MEMORANDUM

DATE: May 30, 2024

SUBJECT: Comments on BPSOU “*100% Grove Gulch Final Submittal*” Received from Atlantic Richfield Company (BP-AR) on 3/22/2024

Materials Management Plan, Figure 2 Waste Excavation Grading Plan

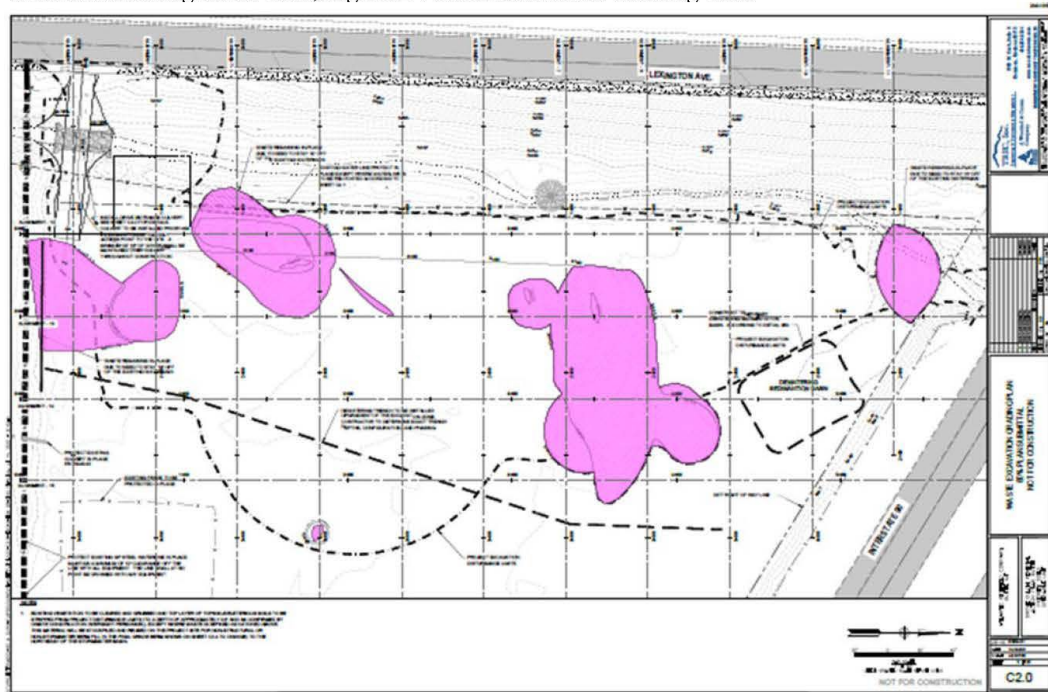
The site investigation, Grove Gulch PDIER and the resulting Figure 2 (Attachment A), is an incomplete and inaccurate approximation of the nature and extent of GG Wastes per Table 1 of the BPSOU CD. According to the Materials Management Plan, Section 1.3 – Project Description, page 8, “Figure 2 shows the extent of waste identified on site.” However, Figure 2 only shows small patches of “waste” within the bigger CD-required area for Grove Gulch. The forms on Figure 2 look like an artifact of sample distribution rather than the nature and extent of fluvially-transported and distributed Waste. General Comment 5 further describes how NRDP believes the EVS model is insufficient as the sole method of waste delineation. Complete delineation of Waste nature and extent requires additional field qualifying methods as well as confirmation sampling. Please identify where in the submittal is the document that describes how Waste will be characterized on the project area.

The site investigation, Grove Gulch PDIER and the resulting Figure 2 (Attachment A), is an incomplete and inaccurate approximation of the nature and extent of GG Wastes per Table 1 of the BPSOU CD. According to the Materials Management Plan, Section 1.3 – Project Description, page 8, “Figure 2 shows the extent of waste identified on site.” However, Figure 2 only shows small patches of “waste” within the bigger CD-required area for Grove Gulch. The forms on Figure 2 look like an artifact of sample distribution rather than the nature and extent of fluvially-transported and distributed Waste. General Comment 5 further describes how NRDP believes the EVS model is insufficient as the sole method of waste delineation.

Figure 3: Waste Characterization and Management Decision Flow Chart

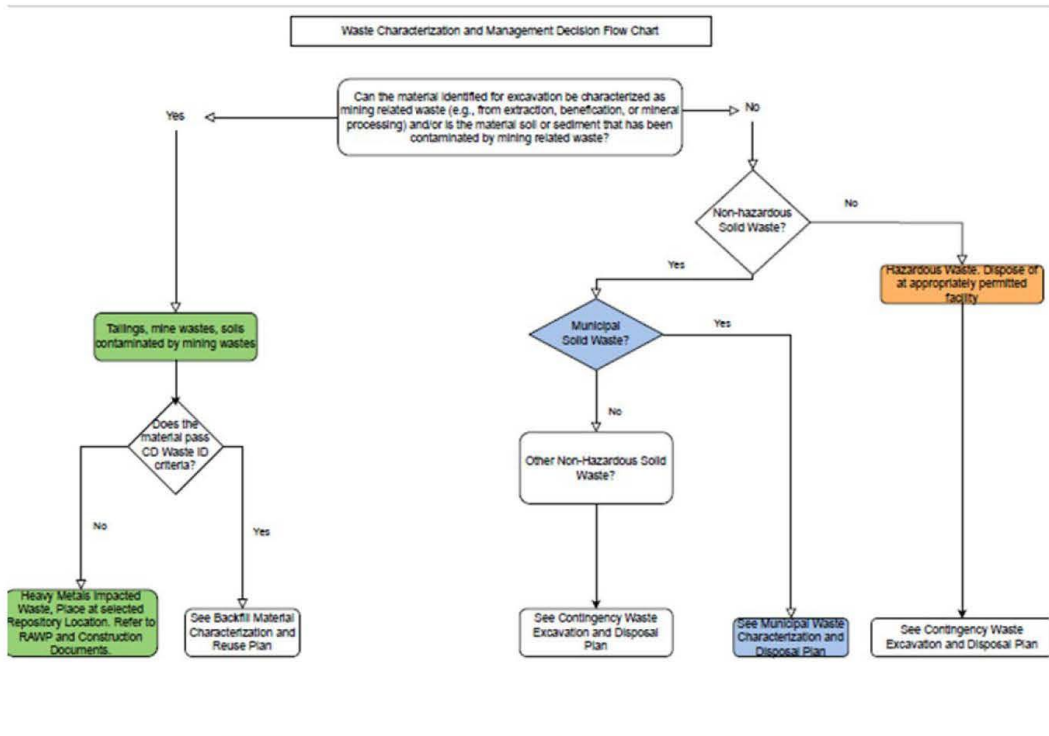
An example of inappropriate reliance on the model to identify Waste is in Figure 3: Waste Characterization and Management Decision Flow Chart (below). Its first decision box states:

“Can the material be identified for excavation be characterized as mine related waste (e.g. from extraction, beneficiation, or mineral processing) and/or is the material soil or sediment that has been contaminated by mining related waste?”

EPA and NRDP commented on the logic of this diagram and that the first box was determined entirely by BP-AR’s EVS model and not sampling (the actual site conditions), which is the CD requirement.

See NRDP's previous comments. Waste should be determined by sampling/analysis and not by the model, which has numerous problems.

2. Figure 3: Waste Characterization and Management Decision Flow Chart (Attachment B)

This decision tree does not explain how “material” will be “identified for excavation.” Is it implied that they will be visually identified? Will they be identified by utilizing Figure 2? Contaminants cannot be identified by visual or accurately predicted by modeling without statistically determined confidence intervals.

"This flow chart is inclusive of material that will be potentially encountered and is a template for following SBCCA sites and therefore will not be changed. Indication of tests to this flow chart at each decision point will be included as a footnote that references the appropriate sections of the MMP. Decisions for characterization and lab analysis are included in Sections 2.1, 2.2, and 2.3 of the MMP and Attachment A of the MMP." (BP-ARs 100% GG Design Cover letter response 26)
